Salinas Valley Water Coalition

Re: Comments on April 2025 Salinas Valley Historical Benefits Analysis Update and May 29, 2025,
Draft Interlake Tunnel and San Antonio Spillway Modification Assessment Engineers Report

MEMORANDUM

RE: Concerns Regarding Monterey County Water Resources Agency's April 2025 Update to Historic Benefits Assessment of Water Infrastructure Projects for Salinas Valley

Figure 1-6 (HBA, 1998) of average increase in water levels elevations resulting from reservoir options from the 1998 HBA modeling.

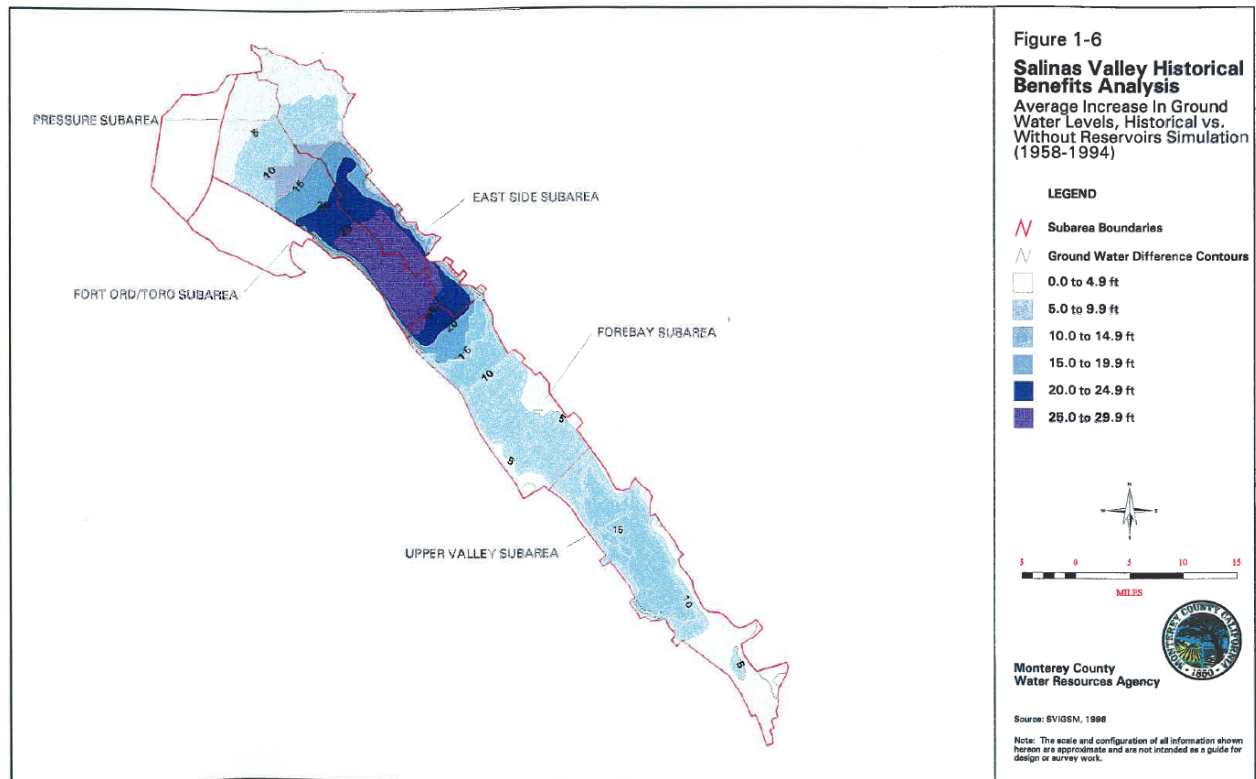
The drain issue in the 2023 provisional version of the SVIHM used for the HBA Update has particular relevance to objectives of the modeling and the HBA Update, because the analysis relies heavily on groundwater elevation differences simulated by the model with and without the reservoirs along with CSIP and SVWP to quantify benefits. I believe that the use of the SVIHM model version with the unacceptable use of “fictitious” drains extensively over the model domain to resolve or mask water budget errors or water elevation errors in the model renders the simulated scenario differences useless for the intended purpose. For note, one of the largest water budget parameter changes observed in the HBA Update modeling is the change in drain outflows (see Table 3-2 from the HBA Update, copy provided below, highlight added)

The unacceptable use of the drains in the SVIHM model version used for the HBA Update analysis is also a likely explanatory reason for the noticeably different model outcomes for predicted water level elevation changes with and without the reservoirs in the 1998 versus 2025 HBA modeling. Predicted groundwater elevation changes as a result of historical reservoir operations were notable in the southern Pressure Subbasin and north Forebay Subbasin in the 1998 SVIGSM modeling, with average water level elevation increases of 10-25 ft (see Figure 1-6 from the 1998 HBA report, included below). Over most of the Salinas Valley, the 1998 modeling indicated a 5-10 ft average water level increase. By comparison, the 2025 HBA Update modeling predicts essentially no average annual water level increase as a result of the reservoirs, with only modest increase directly along the river, and more substantial water level increases in the northern Pressure subbasin as a direct result of CSIP/SRDF. In review of available historical water level elevation data, it appears that a historical rise in water level elevations post-reservoirs (1958 for Nacimiento) as represented in the 1998 modeling is supported by the data, but perhaps of a more modest magnitude of approximately 5-15 ft (reference is made to hydrographs of water level elevations for 1948-1994 in the Appendix A to the HBA, Montgomery Watson, 1998).

The lack of predicted water level elevation responses from the reservoir operations and inconsistency with the prior body of work from the 1998 HBA modeling, which was a significantly peer reviewed effort, should have led to questioning of the validity of the results being observed in the HBA Updated modeling.
